17-23 Talavera Road, Macquarie Park Construction Traffic Management Plan

Prepared for:
Macquarie Data Centres Pty Ltd

12 June 2024

Table 1.2: Response to Council's Comments Received on 2/5/2024

Figure 3.1: Nominated Construction Vehicle Routes

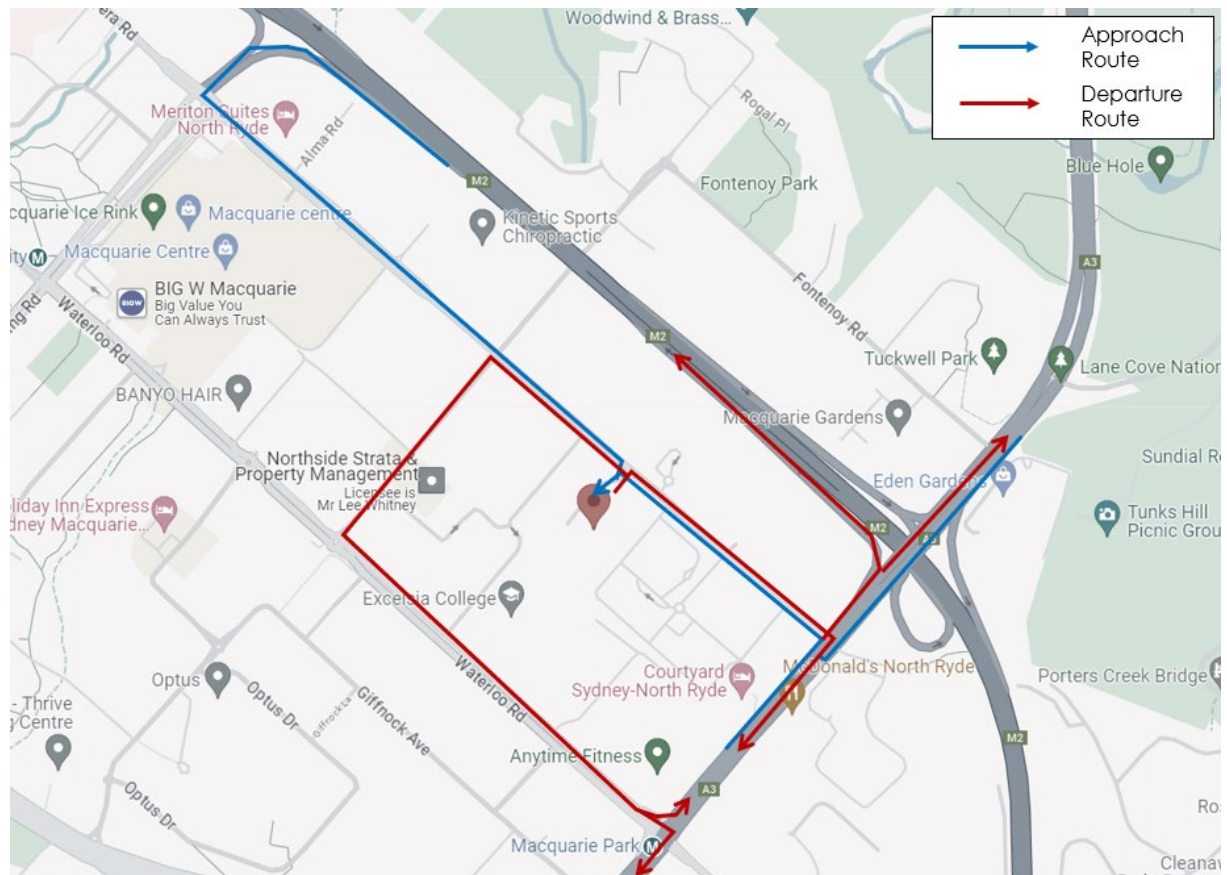
3) Truck routes: the departure route is required only turning right onto Talavera Road from the site and then turning left/right onto Lane Cove Road. The reasons for such a requirement are listed here: - The construction works of Macquarie University Bus Interchange would start soon, which include the reconstruction works of Herring Road/Talavera Road intersection. - Some construction sites at Waterloo Road have been approved to use Talavera road section between Herring Road and Khartoum Road already. - The previous approval of truck exiting route to use Herring Road during stormwater and sewer alignment stage is based on limited truck demand and short construction timeframe. The proposed construction timeframe for this CTMP would last 2 years. The truck route has to be regulated with minimum truck number on Talavera Road between Khartoum Road and Herring Road. If some trucks have to use M2 on-ramp at Herring Road due to various reasons, this should be minimised. Please also explain why these trucks have to use M2 on-ramp via Herring Road in the CTMP report.	Truck route modified. Trucks will not be exiting via Herring Road. See Section 3.6 for further detail.

On a local level, the designated truck routes to/from the works site shall be provided off Talavera Road in order to travel to/from the wider arterial road network via Lane Cove Road and the M2 Motorway as shown in Figure 3.1.

Figure 4.1: Operational Staff Pedestrian Access

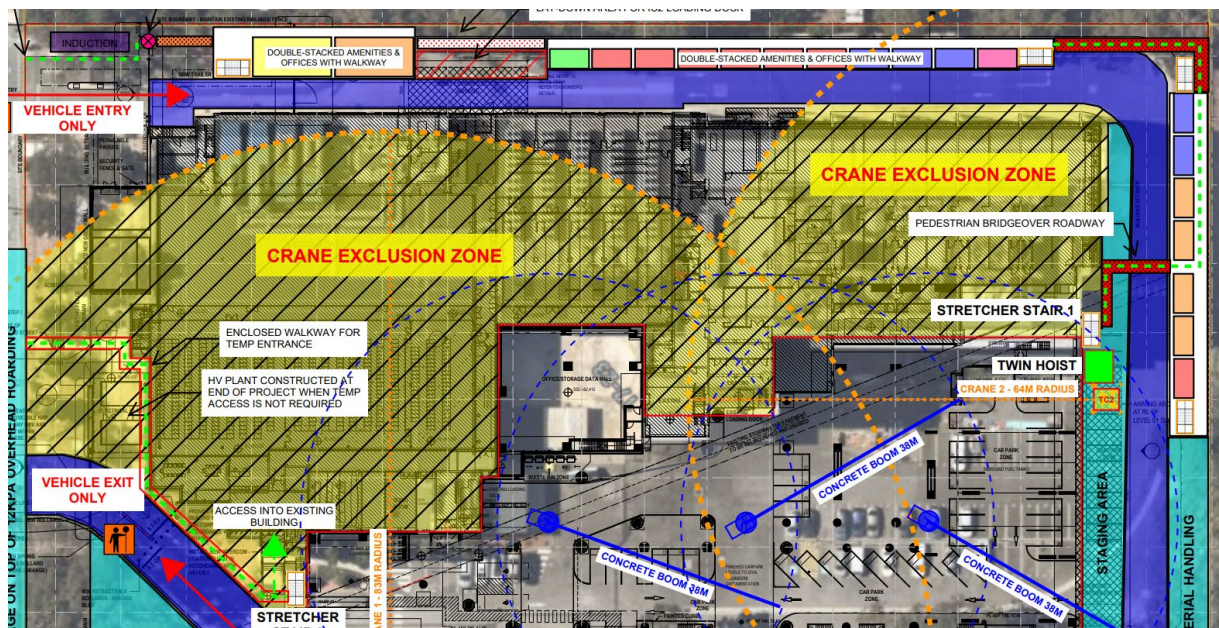
5) The issue of pedestrian bridge with 3m low clearance. The 3m low clearance of the internal pedestrian bridge leads to the issues as described in comments 4.1) & 4.2). This is advised to increase to 4.5m.	The pedestrian bridge has been raised to permit a height of 4.5m. See Section 4.2 for further detail.

The internal driveway below the temporary pedestrian bridge would have maximum head clearance of 4.5m. Contractor is to ensure that all construction vehicles accessing the site are below a height of 4.5m.
